INDIANA DEPARTMENT OF TRANSPORTATION

Design Memorandum No. 23-04

SUBJECT: *Indiana Design Manual Chapter 503*

REVISES: Sections 503-1.0, 503-2.0, 503-2.01, 503-2.02, 503-2.02(01), 503-2.02(02), 503-2.04, 503-2.04(01) thru 503-2.04(04), 503-2.05(01) thru 503-2.05(05), 503-2.06(01), 503-2.07, 503-3.01(01), 503-3.01(03), 503-3.01(04), 503-3.02, 503-3.04, 503-3.04(02) thru 503-3.04(04), 503-3.05(02), 503-3.05(04), 503-3.05(07), 503-4.01, 503-4.02, 503-6.01, 503-7.01(02), 503-7.01(03), 503-7.01(05), 503-7.02, 503-7.02(01), 503-7.02(04), 503-7.02(05), 503-7.03(01), 503-7.04(02), 503-7.05, 503-7.07, 503-7.07(01) thru 503-7.07(04) (new)

Figure 503-3G

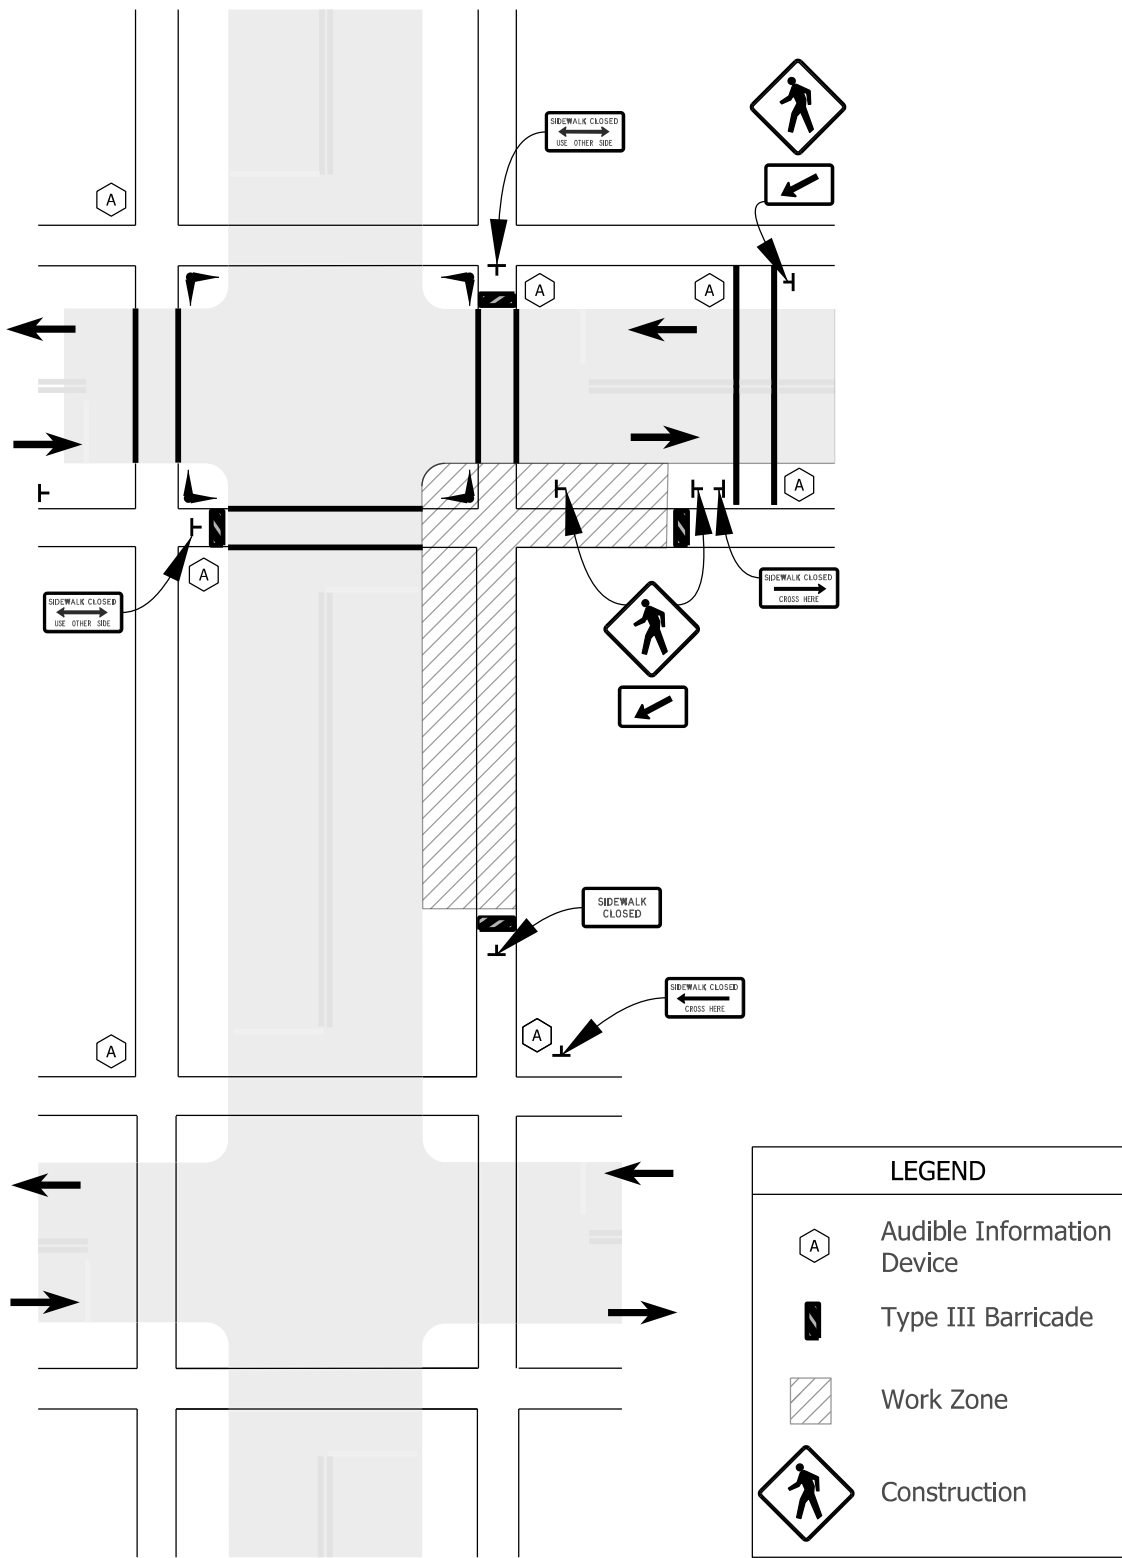
| IDM Section | Title | Revision |
|--------------|--|--|
| 503-3.01(04) | Design Considerations, Items 13 and 14 | Additional guidance on maintaining pedestrian accessibility during construction. A new hierarchy on selecting the strategy to accommodate pedestrians is provided: if sidewalk is to be closed or restricted that first a pedestrian diversion be considered (temporary path adjacent to the closed sidewalk). If a diversion is not viable, then a pedestrian detour be established. Additional detail on devices used in diversions and for detours is also provided. |

| IDM Section | Title | Revision |
|--------------|--|---|
| 503-7.07 | ADA Compliant Temporary Pedestrian Devices | New Content was added to detail ADA Compliant Temporary Pedestrian Devices including temporary pedestrians accessible paths, curb ramps, channelizers, and audible information devices. |

- ① Temporary pedestrian access route width of 60 in. is preferred. A 48 in. width may be used if at least one 60 in. by 60 in. passing space is provided every 200 ft.
- ② Temporary curb ramp that covers any rough, soft, or uneven ground, has a turning space of 48 in. by 48 in., an 8.00% or flatter running slope, a 2.00% or flatter cross slope, and a non-slip surface. Edge protection is required for curb heights > 4 in. and handrails are required for curb heights > 6 in.
- ③ Temporary pedestrian channelizer
- ④ Temporary accessible pedestrian path
